NAVION SERVICE LETTER # 87
FEBRUARY 20, 1965

MANDATORY

SUBJECT: Fuel Accumulator Tank - Replacement
EFFECTIVITY: All Model Navions
REFERENCE: Ryan Service Letter #78
DRAWING: Tanks experienced corrosion - Item #2307 - P/N 145-48004
Replacement Tanks - Item #2307-10 P/N 145-48006

FUEL SYSTEM ACCUMULATOR TANK MAINTENANCE AND MODIFICATION

Figure 1 - Accumulator Tank Bracket

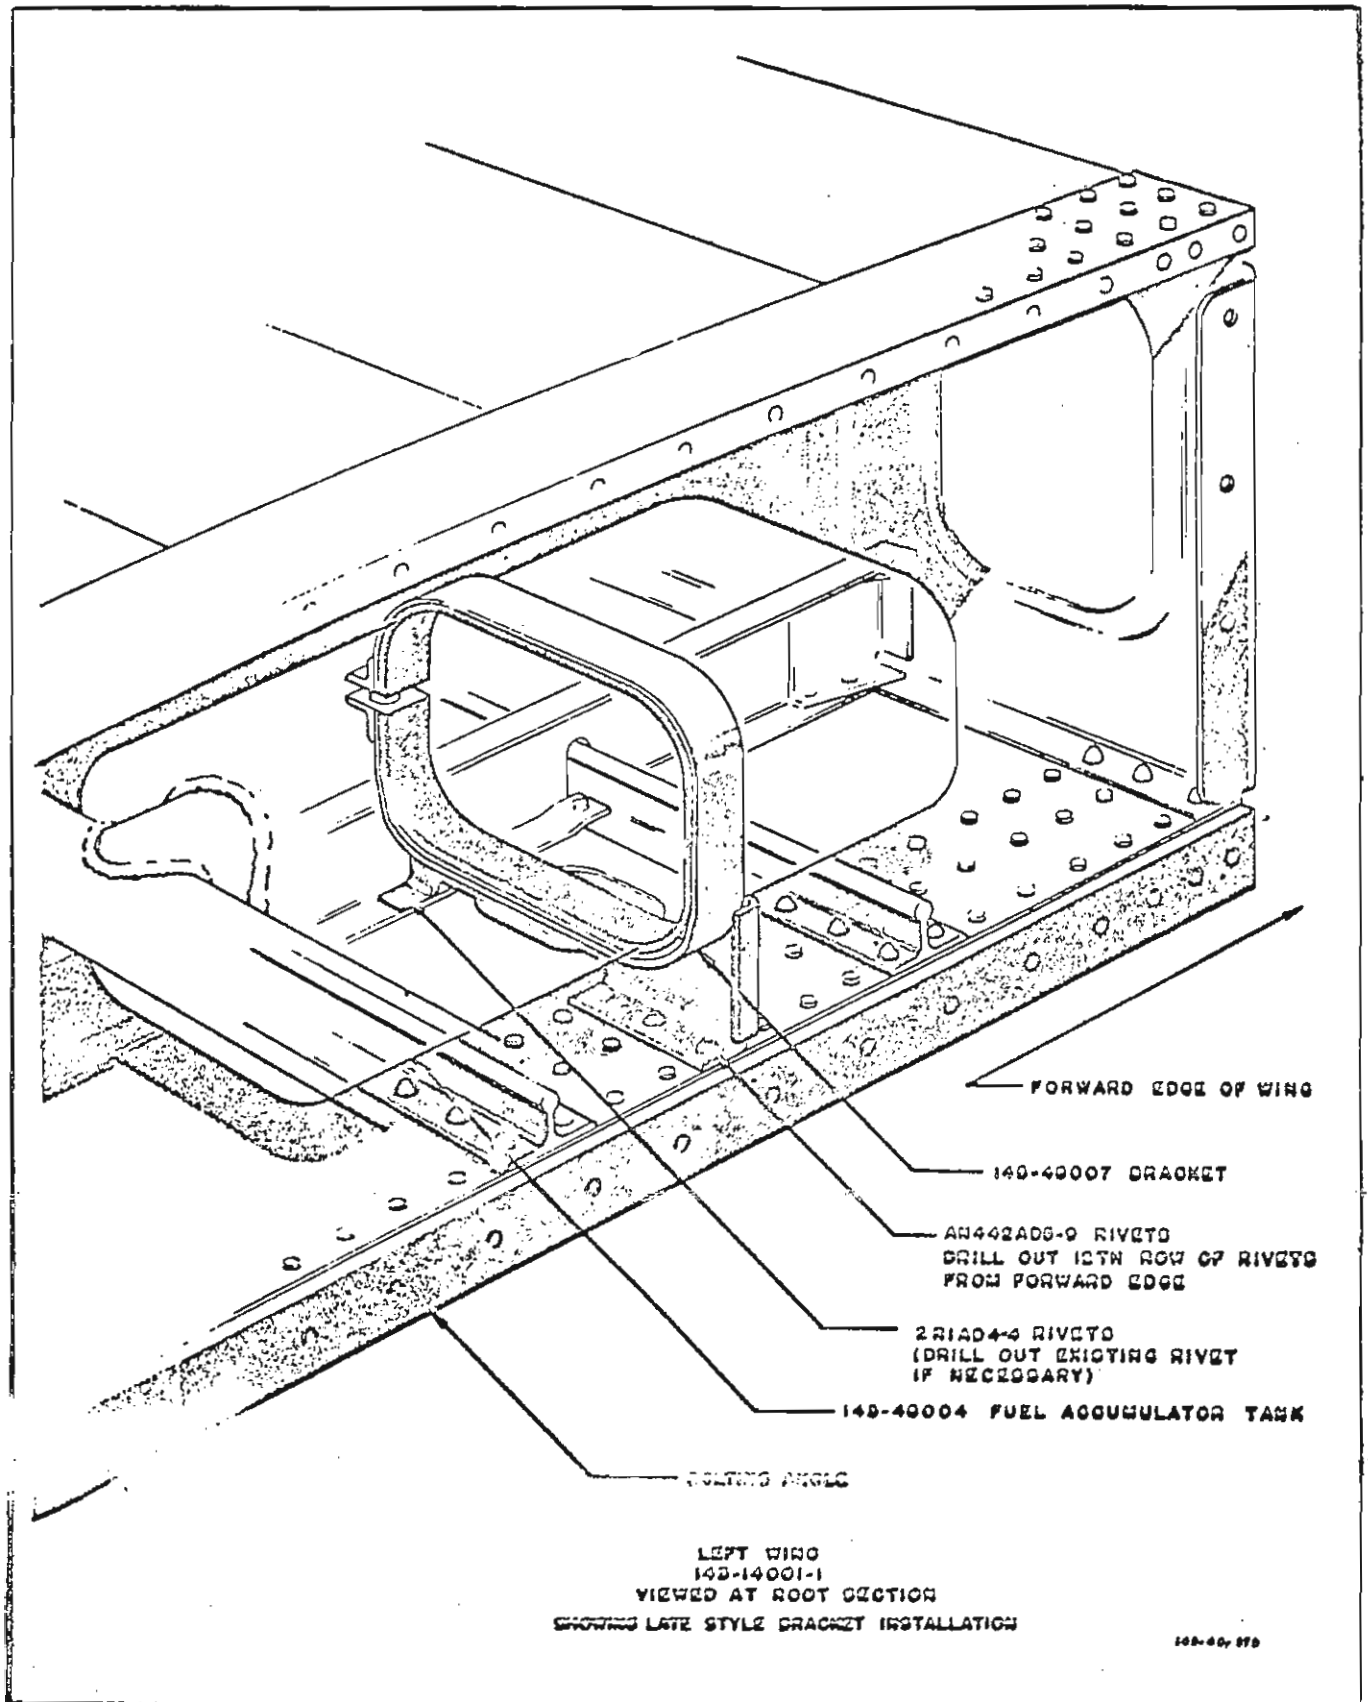
Navion airplanes prior to factory serial number NAV-4-1251 have the fuel accumulator tank supported by two 145-48008 brackets riveted to the 143-14010-20 center rib. Airplanes subsequent to NAV-4-1251 have the fuel accumulator tank supported by one 145-48007 bracket, riveted to the bolting angle of the left wing.

SEE FIGURE 1

1. Inspect inside the root section to see if fuel accumulator tank bracket 145-48007 is installed. If the 145-48007 bracket is installed, remove it from the wing as follows:
 - a. Drill out the three AN442AD5-9 rivets which attach one end of 145-48007 bracket to the wing bolting angle. This is the 12th row of rivets aft of forward edge of the wing.
 - b. Drill out one 2R1AD4-4 rivet attaching the outboard end of the 145-48007 bracket, and remove bracket from wing.
 - c. Replace the first three removed rivets with AN442AD5-9 rivets. Replace the removed outboard rivet with one 2R1AD4-3 rivet.

1. Inspect the inside root section of left wing to see if the 145-48007 fuel accumulator tank bracket is installed. If bracket is not present, install the new 145-48007 bracket, received as a loose part, as follows:
 - a. Drill out three AN442AD5-8 rivets which run spanwise in the bolting angle. This is the 12th row of rivets aft of the forward edge of wing.
 - b. Clamp 145-48007 bracket in the wing with the flange of bracket over holes just drilled. Drill through bolting angle holes and bracket flange with a No. 21 (.159) drill.

CAUTION: Do not elongate holes in bolting angle.

- c. Attach bracket to bolt angle with three AN442AD5-9 rivets.
- d. Drill through rib, wing skin, and pilot hole on outboard flange of bracket with No. 30 (.128) drill, and install one 2R1AD4-4 rivet.
